REMARKS

The non-final Office Action dated February 18, 2009 indicated an objection to the drawings and listed the following new grounds of rejections: claims 1-16 stand rejected under 35 U.S.C. § 112(1) and § 112(2); and claims 1-16 stand rejected under 35 U.S.C. § 103(a) over Letavic (U.S. Patent No. 6,127,703) in view of Nakagawa (U.S. Patent No. 4,614,959). Applicant traverses all of the rejections and, unless stated by the Applicant, does not acquiesce to any objection, rejection or averment made in the Office Action.

FIG. 1

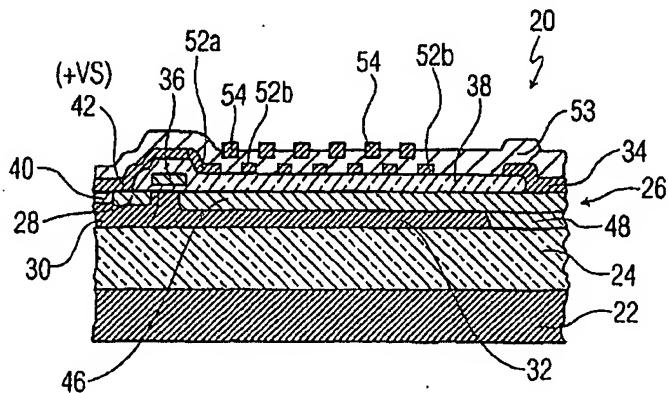
Regarding the drawing objections, Applicant has submitted amendments herewith, consistent with the previously-filed drawing amendments, which should render the objections relative to item numbers 48 (no longer present), 34 (redirected) and 44 (added) moot. Regarding the Office Action's indication that embodiments for limitations wherein "the field plate is connected to the gate electrode" must be shown, Applicant submits no amendments should be required because FIG. 1 together with the discussion at paragraph 0021 and the incorporated references convey an understanding of the claimed invention in accordance with 37 C.F.R. §1.83(a). Specifically, FIG. 1 (copied below) shows a field plate (e.g., portion 52a) on an insulation layer above the gate electrode (e.g., 38) and connected to a source region (e.g., 42).

As described at paragraph 0021, "the field plate 32 may be an extension, or connected to, the gate electrode 36 instead of the source region 42." Such a connection is further shown in the references incorporated in the instant application, and would be well understood by one of skill in the art (e.g., the extension region 52a may be connected to the gate 36 through the insulator 38). Therefore, Applicant believes that the drawings are

Notwithstanding the above, Applicant believes that the objection to the drawings regarding the gate-plate connection are no longer applicable in view of the amendment to FIG. 1. Amended FIG. 1 shows an exemplary connection 37 (dashed lines) between the region 52(a) and the gate 36 (e.g., in lieu of the connection between region 52A and the source extension 42). Applicant notes that a multitude of other such connections may be made in accordance with one or more embodiments of the invention. The replacement drawings also show removal of reference number 48, redirection of number 34 and the addition of number 44 as consistent with the previously-submitted drawings, with region 34 in FIG. 1 shown in a manner that is consistent with region 34 in FIG. 2. Applicant believes that the objection to the drawings is no longer applicable in view of the above, and requests that it be removed.
